STAFF REPORT

October 6, 2015

AGENDA ITEMS: File No. 14004

Consideration of a Transit Oriented Development (TOD) master plan on 18.91 acres in the Eastside TOD district. The project site is located east of Gebhard Road and north of Beebe Road, and is identified on the Jackson County Assessor's Map as 37S 2W 02 Tax Lots 2700 and 2701. The project site is within the LMR—Low Mix Residential (2.69 acres) and MMR—Medium Mix Residential (16.22 acres) zoning districts. **Applicant:** People's Bank of Commerce; **Agent:** Tony Weller, CES|NW.

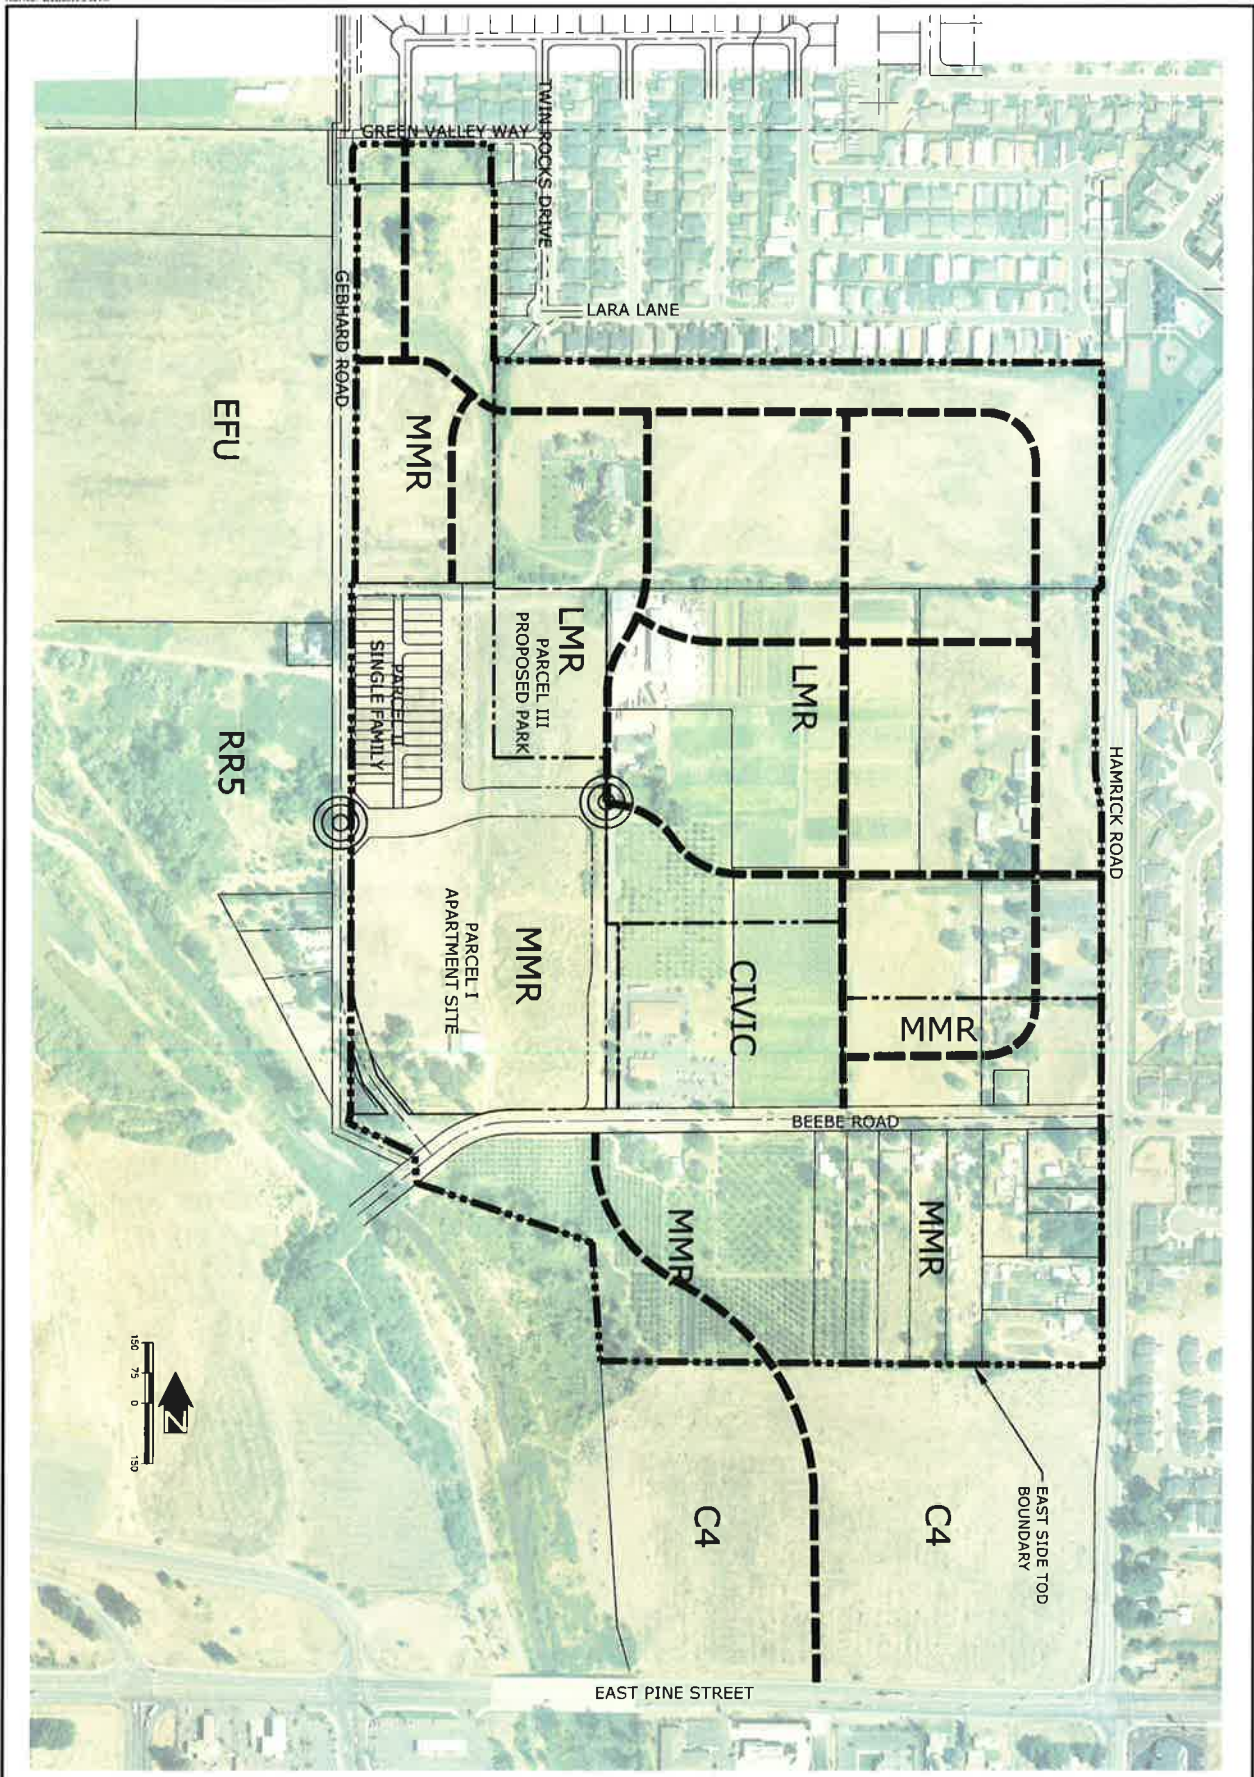
- The Transportation and Circulation Plan (Attachment “B” Exhibit “7”) was amended to provide additional right-of-way as necessary to accommodate the future extension of Gebhard Road south to East Pine Street per the City’s Transportation System Plan (TSP) and the Gebhard Road Alignment Study.

Resolution: Prior to final plat approval, an updated TIA based on the proposed development phasing plan and a current construction schedule shall be submitted to, and approved by, the City. The updated TIA will need to include the final traffic impacts relative to each dwelling unit added and the identification of when the Beebe and Hamrick Road intersection will warrant signalization. Based on the updated TIA the City will identify a trip cap measured in terms of dwelling units which must not be exceeded until completion of signalization.

- e. The master plan shall be amended to show White Hawk Way extending to the north of Beebe Park Drive thru the park site as a ROW reservation.
3. The park improvements shall be completed prior to certificate of occupancy for any building within Phase 2 and 3.
